Contract No. HK/2009/01

Wan Chai Development Phase II – Central -Wan Chai Bypass at  
Hong Kong Convention and Exhibition Centre

## Silt Screen Deployment Plan

EP Condition 2.9: Updated Silt Screen Deployment Plan (Revision 4)

**Appendix A**  
**Location Plan for Type 1 to 3 Silt Screen**

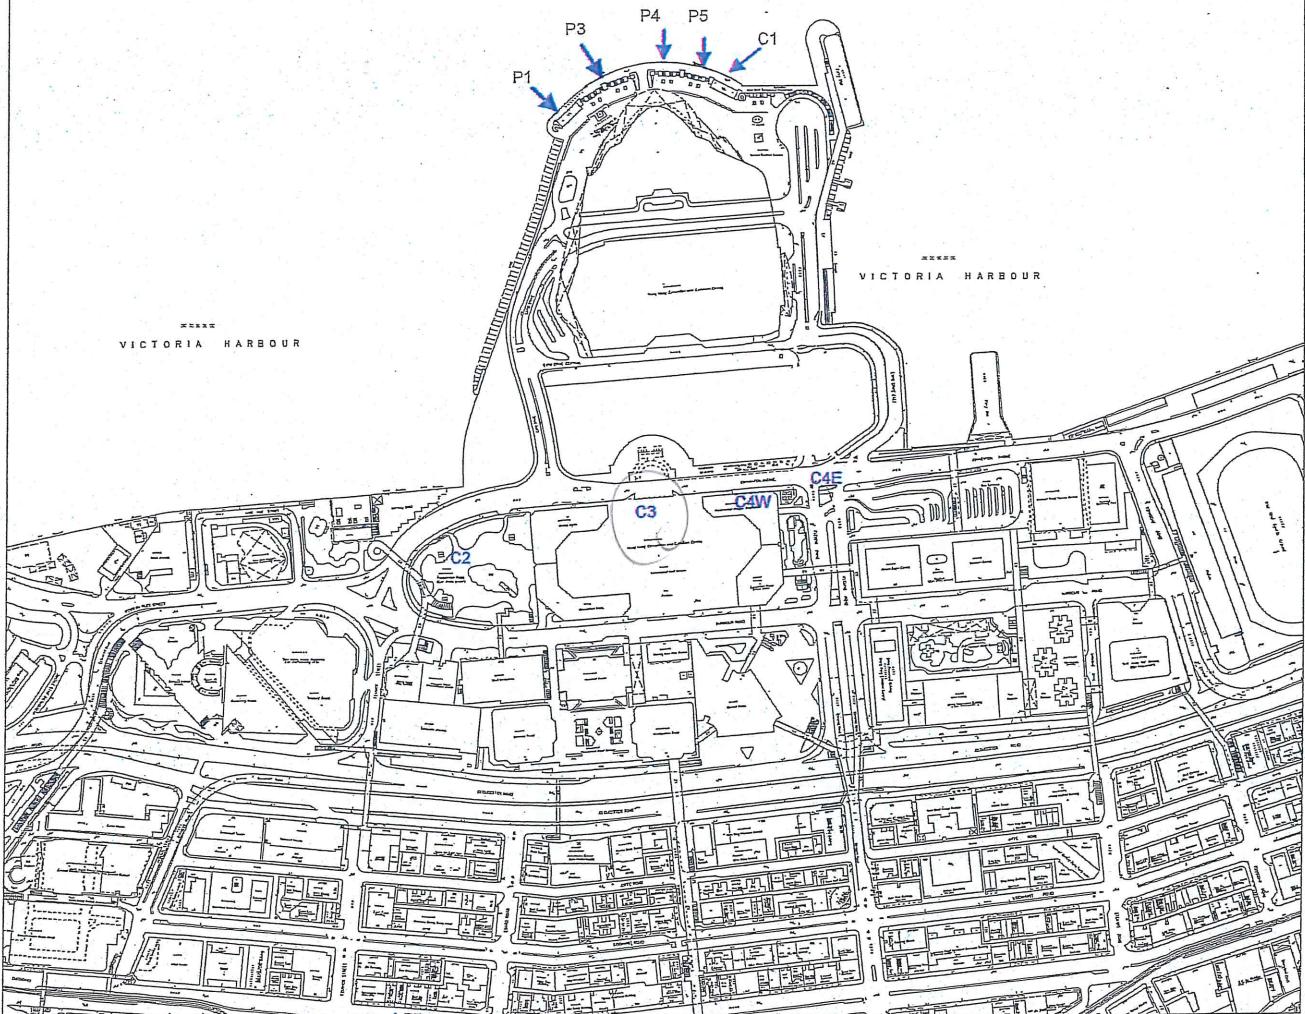
- (1) Some figures and texts in the appendixes (e.g. App.A - Location Plan; App.F - Arrangement of Access Provision for Water Monitoring, etc) are so blurred and not easy to read, please provide figures with higher resolution;
- (2) Please add a paragraph to outline why amendment of plan is necessary at, say section 1.1 Introduction, to facilitate the general reader to follow the logic; and
- (3) Please review the submission to ensure the general fluency and to prevent minor grammatical mistakes.
